Docket Nos. 50-269,50-270
and 50-287

SUBJECT: NUREG-0737 ITEMS II.K.3.1 - AUTOMATIC PORV ISOLATION AND
II.K.3.2 - REPORT ON PORVs FOR OCONEE NUCLEAR STATION

SAFETY EVALUATION BY THE OFFICE OF NUCLEAR REACTOR REGULATION
OF B&W LICENSEES' RESPONSES
TO NUREG-0737 ITEM II.K.3.2

Figure 1. B&W Calculation

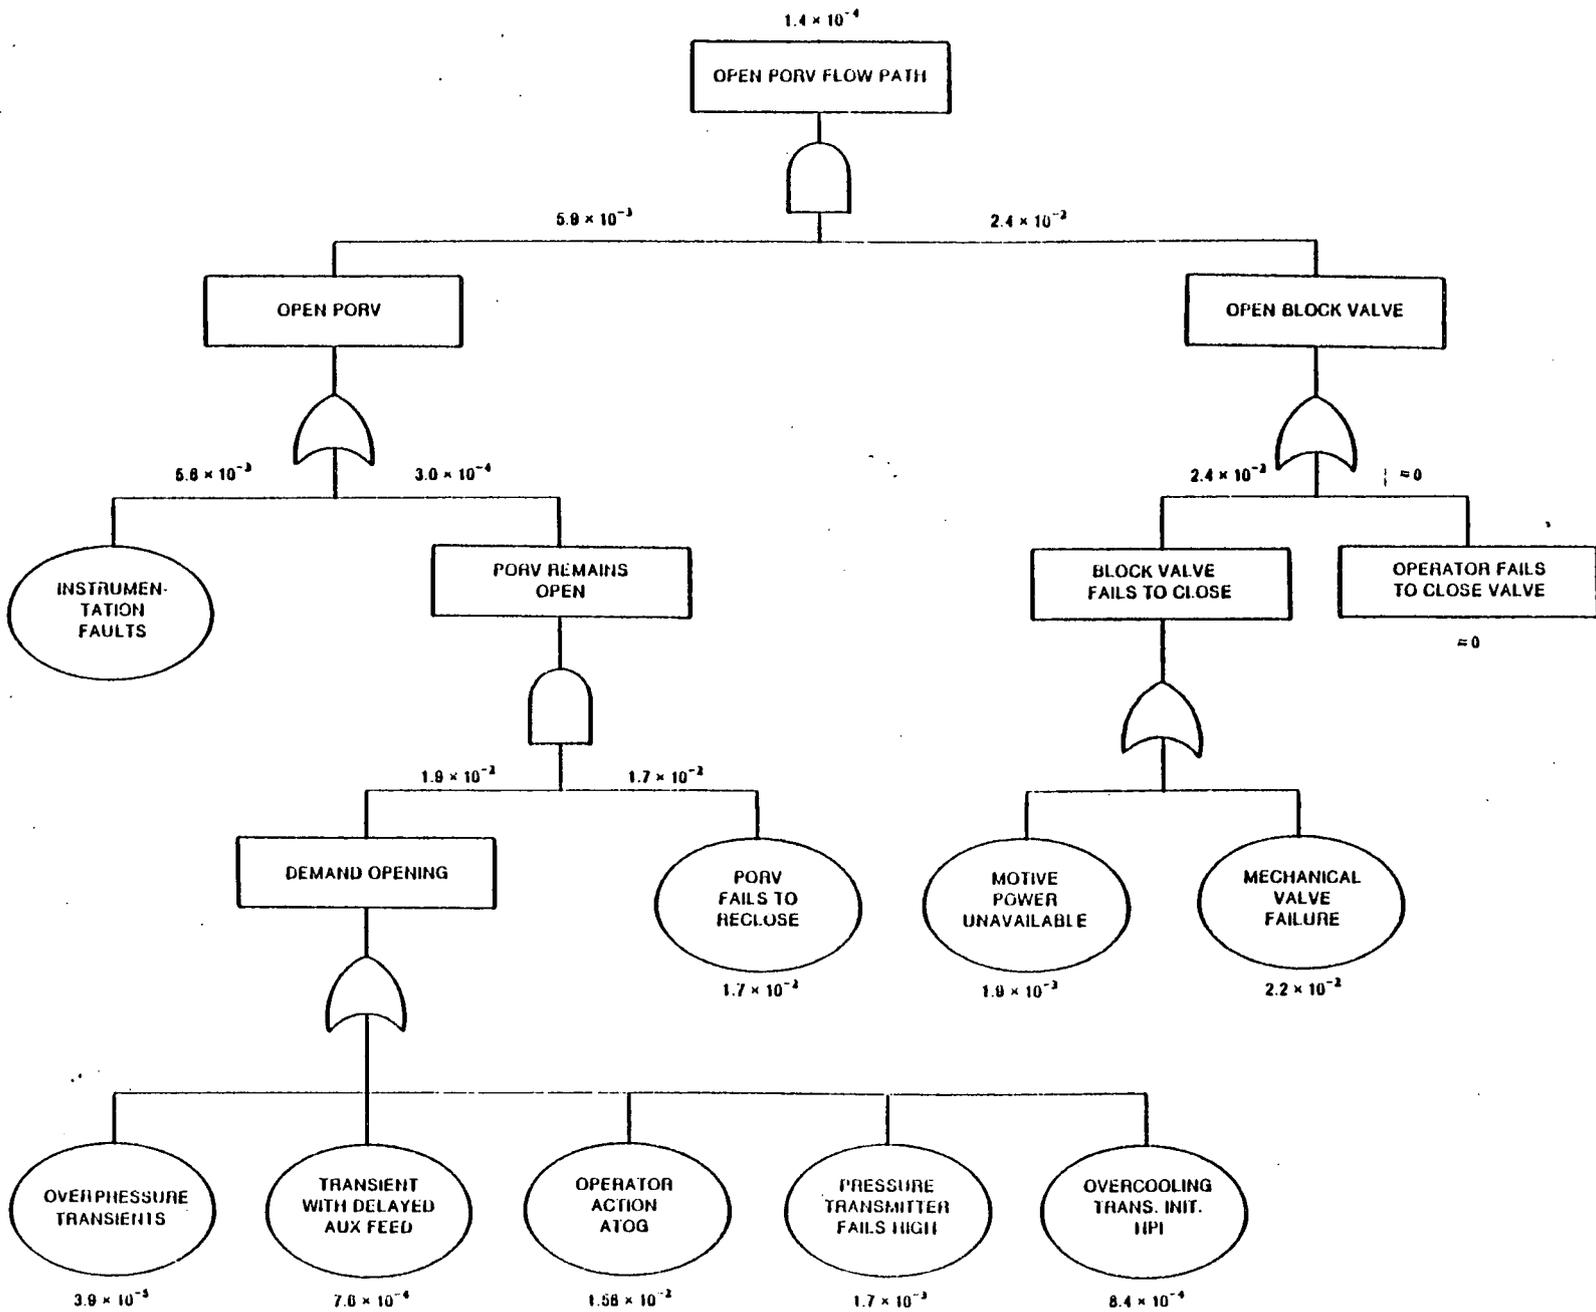
As shown in Figure 1, B&W determined the recurrence frequency of a small-break LOCA from a stuck-open PORV by multiplying the probability of the PORV remaining open with the probability of the block valve remaining open. The probability of the PORV remaining open is the sum of openings due to instrumentation faults and openings due to other demands multiplied by the probability of the PORV to fail to close. Figure 1 shows that B&W determined the probability of a small-break LOCA from a stuck-open PORV to be 1.4×10^{-4} per reactor-year.

Figure 2. (Page 1) Revised Calculation

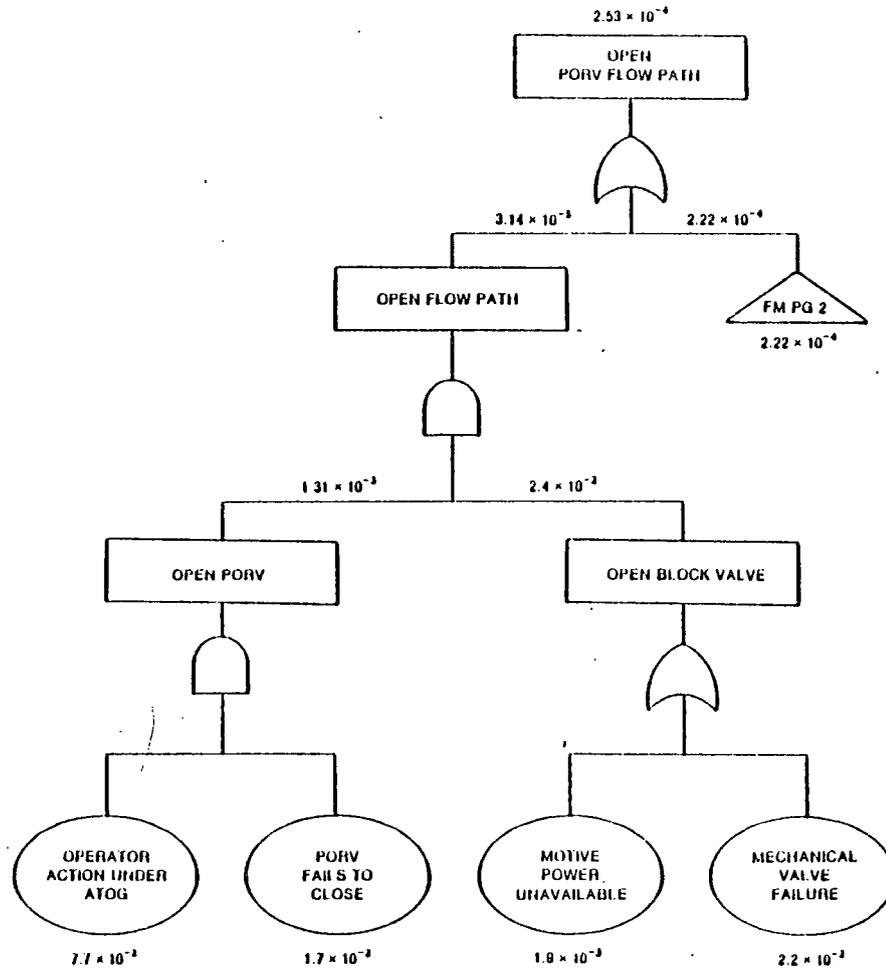
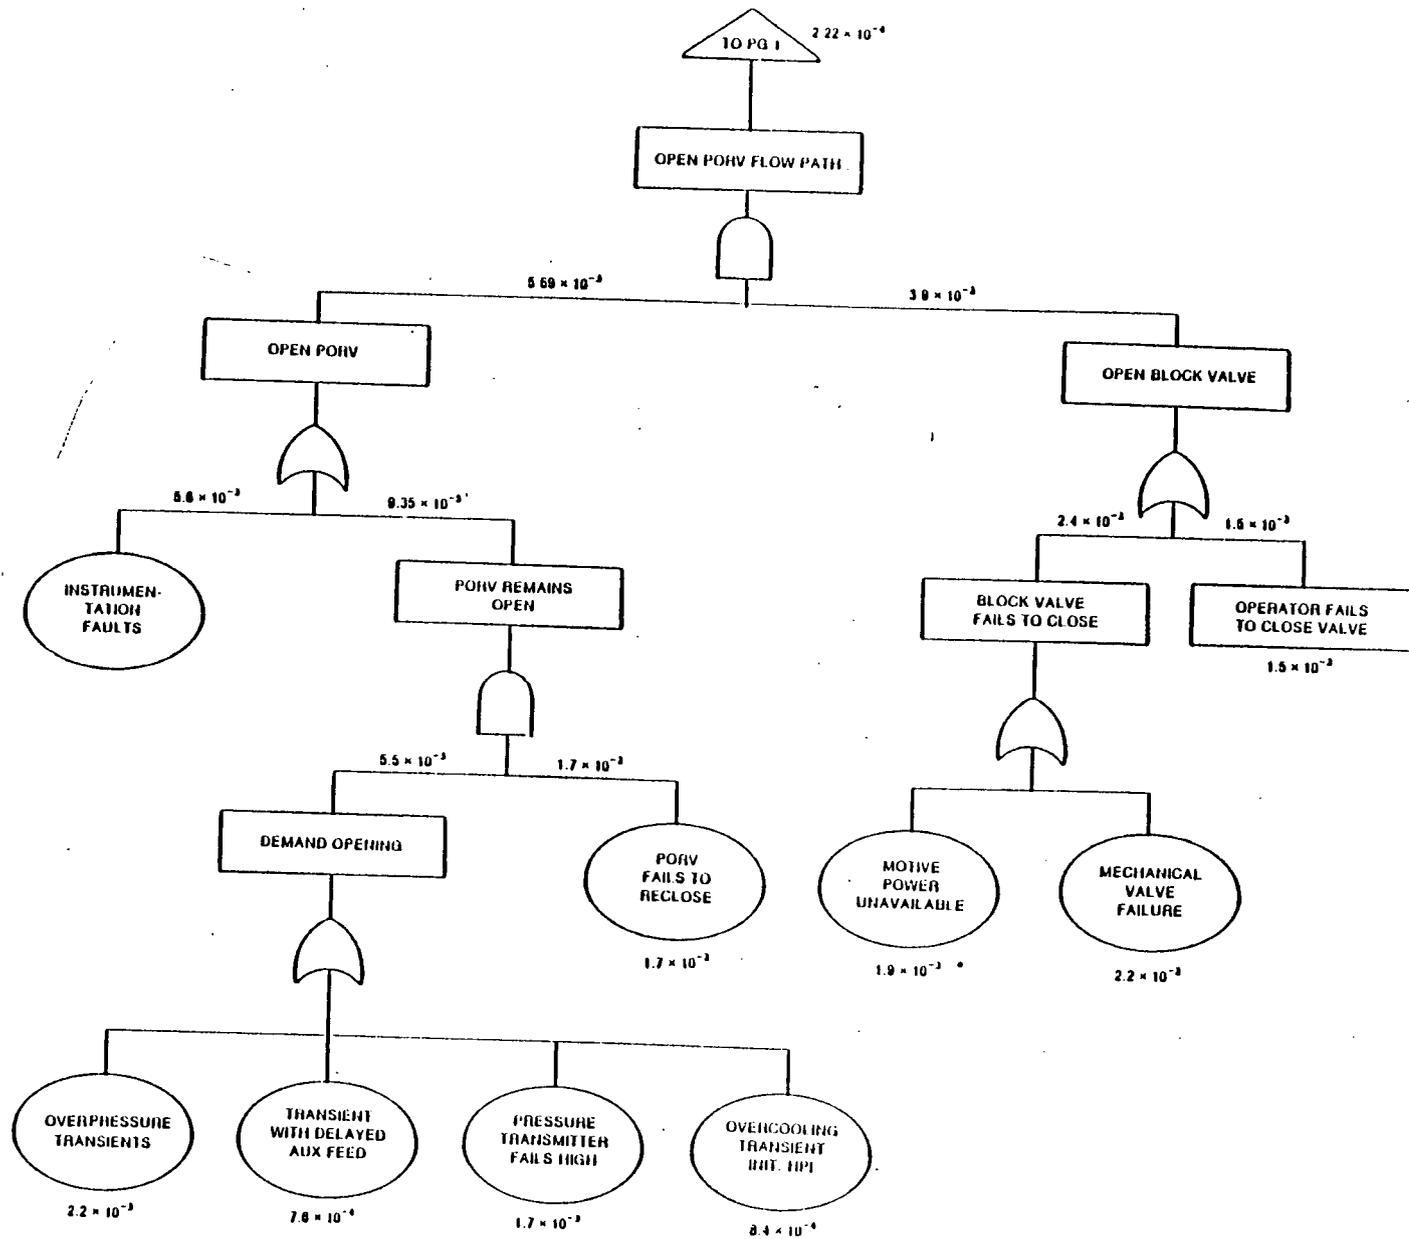
Figure 2 shows the same calculation revised in accordance with the comments and discussion developed in this section of the report. It includes changes made to the initiator frequency for overpressure transients (2.2×10^{-3} rather than 3.9×10^{-5}), the initiator frequency for operator action under ATOG guidelines (7.7×10^{-2} rather than 1.58×10^{-2}), and the probability of the operator failing to shut the block valve when required (1.5×10^{-2} per demand rather than 0). As result of this recalculation, the probability of a small-break LOCA from a stuck-open PORV is 2.53×10^{-4} per reactor-year. While this value is somewhat larger than the value determined by B&W, it is quite comparable and is also well below the median WASH-1400 frequency for a small-break LOCA of 1×10^{-3} .

Figure 3. (Page 1) Revised Calculation, Considering Multiple PORV Cycles

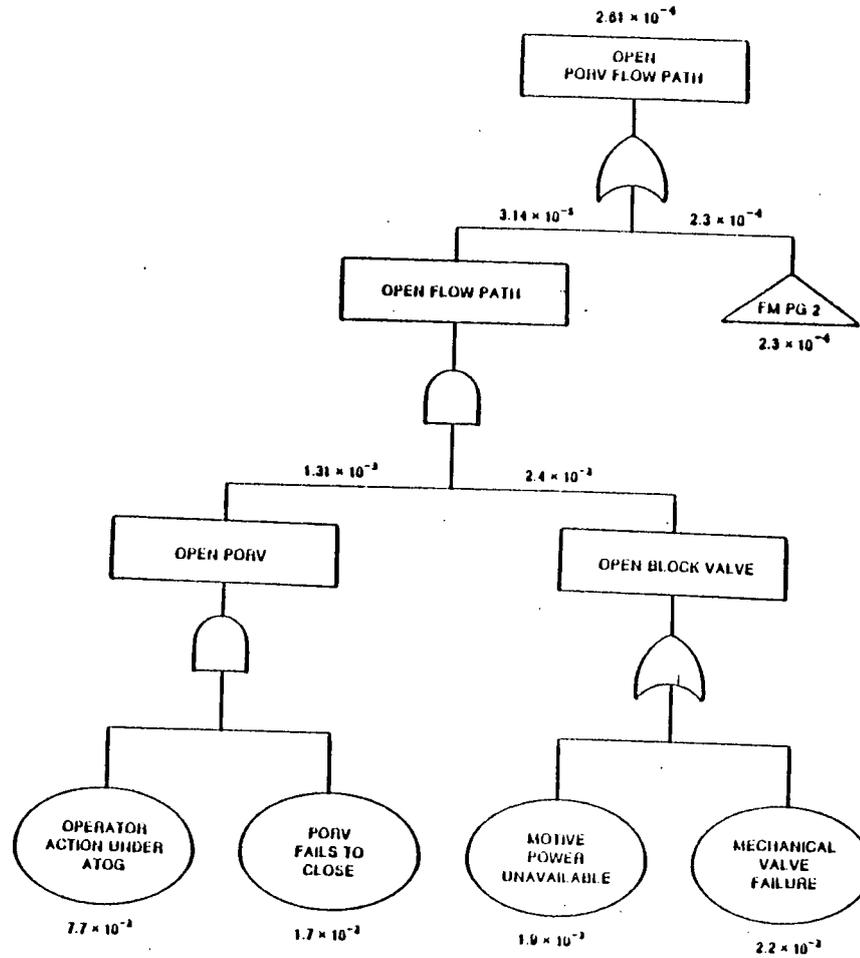
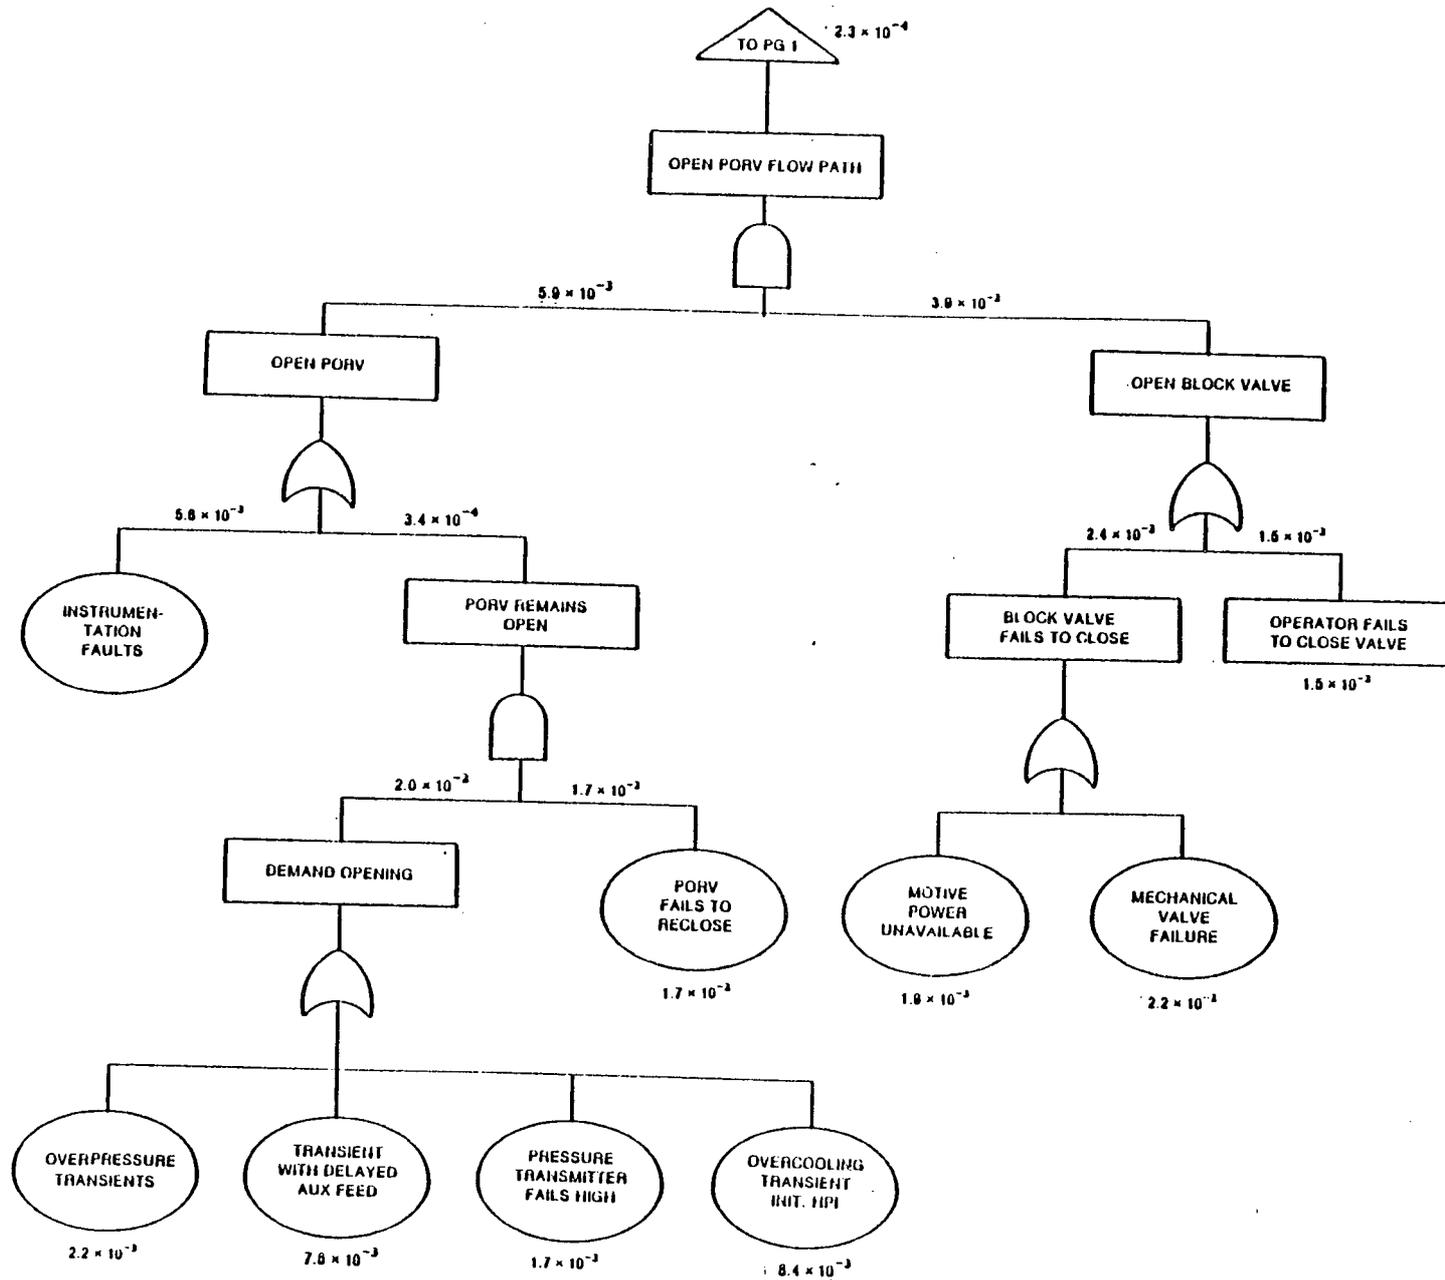
The revised calculation of Figure 2 (discussed in Section 3.2.1.2) has been updated to include the effect of multiple PORV cycles. The results of this updated analysis are given in Figure 3. Figure 3 shows a small-break LOCA probability of 2.61×10^{-4} per reactor-year, a 3.3% increase over the value calculated in Figure 2. These calculations show that multiple PORV cycles is not a primary concern for B&W-designed units.

Figure 4. Operational Data Event-Tree

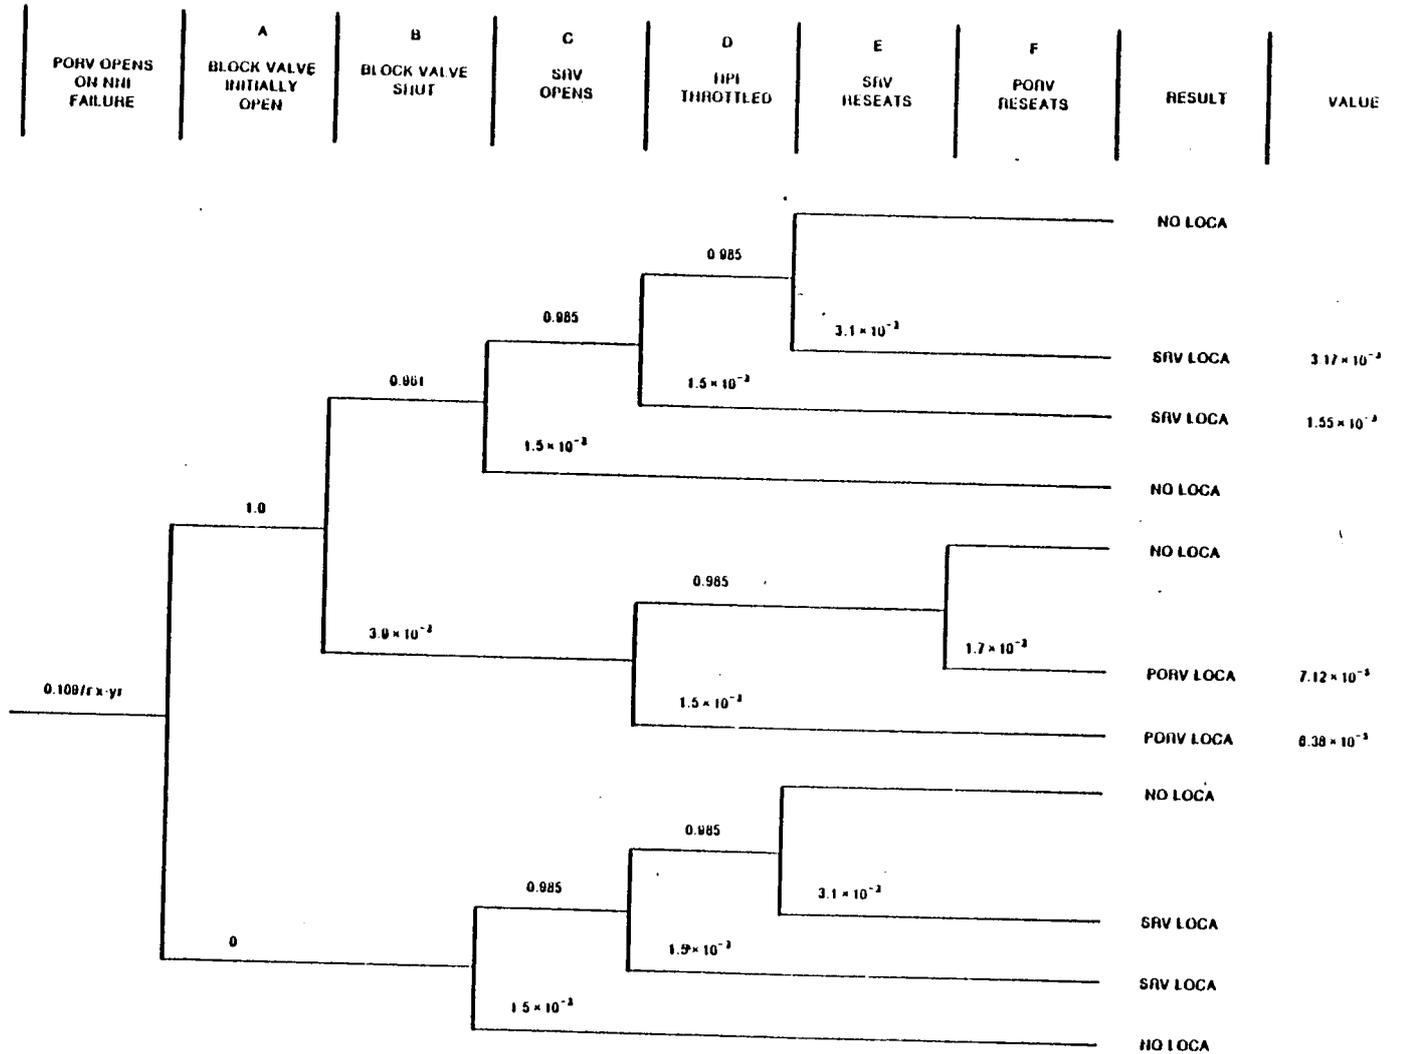
As shown in Figure 4, the small-break LOCA probabilities resulting from this analysis are:

The results indicate that the probability of a small-break LOCA from a stuck-open PORV or SRV remains within the WASH-1400 range of 10^{-2} to 10^{-4}
